Contract #: 04-0120F4Cty: SF/ALA Rte: 80 PM: 13.2/13.9File #: 69.25B**QUALITY ASSURANCE -- NON-CONFORMANCE REPORT****Location:** Shanghai, China**Report No:** NCR-000010**Prime Contractor:** American Bridge/Fluor Enterprises, a JV**Date:** 03-Oct-2007**Submitting Contractor:** Zhenhua Port Machinery Company, Ltd (ZPMC), Changxing Island**NCR #:** ZPMC-0010**Type of problem:**

Subject: NCR No. ZPMC-0010

Reference Description: Repairs to longitudinal stiffener welds greater than 10% in length on the 114m Mock-up

SUBJECT: RESPONSE TO NCR-0009 AND 0010

DRAWN: [Signature] SHEET NO. RP-01
CHECKED: [Signature] 2007-10-20 ORDER NO.

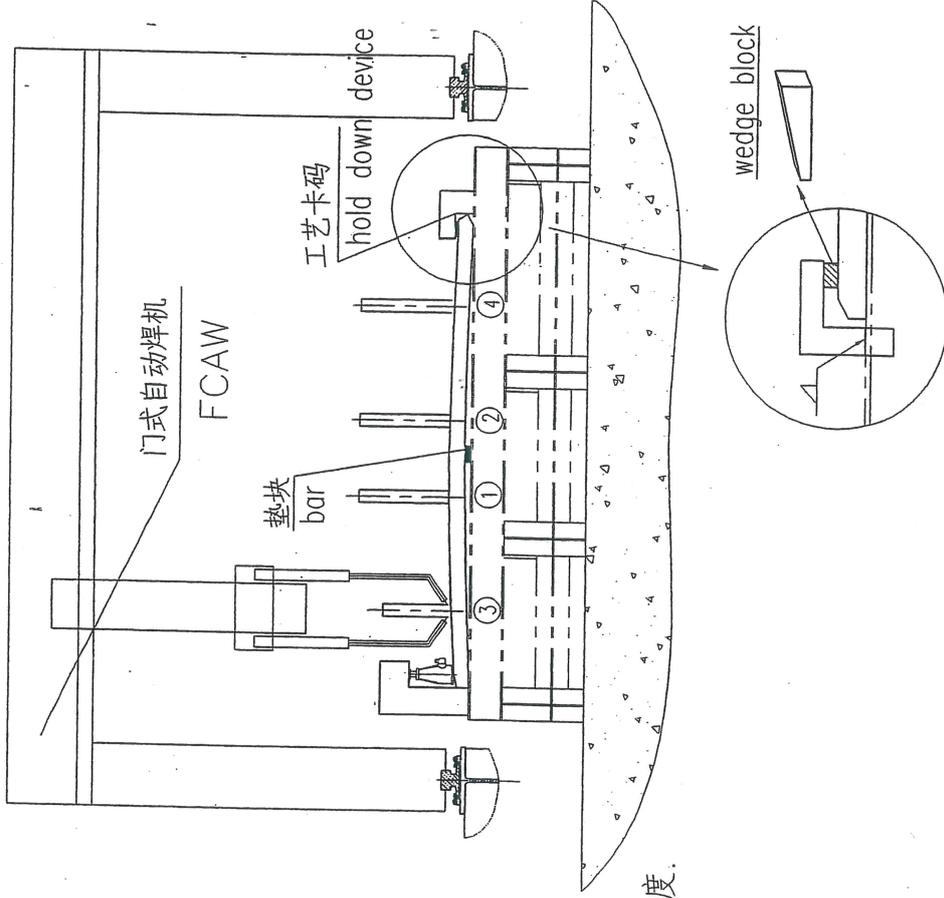
ABF has allowed the fabrication to proceed with making repairs to rejectable indications found in the complete joint penetration (CJP) welds which connect Skin Plates B upper panel to the longitudinal stiffener mp1006, weld joint MUSC-MA101-8 of the 114m mock-up. These indicators were found using Ultrasonic Testing (UT) at lengths greater than 10% of the cumulative length of the welds.

Step 1. Fit up of Longitudinal Stiffener to Skin Plate.

- 1.1. 在装配纵向筋之前, 按照已批准的图纸要求将纵向筋加工到位,
 - 1.1.1. Machine approved weld detail bevels onto longitudinal stiffeners.
 - 1.1.2. 在面板上划好纵向筋的装配线.
 - 1.1.2 Lay out Skin plate and mark longitudinal stiffener positions.
 - 1.1.3. 在两端增加好可调卡码(如右图), 安装并根据已批准的WPS的要求把纵向筋点焊固定在面板. 检测其垂直度.
- 1.3 Install adjustable holding down device, assemble and tack weld the longitudinal stiffeners to Skin plate inline with the parameters of the approved WPS and check the verticality to the Skin plate.
- 1.4. 对所有尺寸进行检查.
 - 1.4. Check all the dimensions.
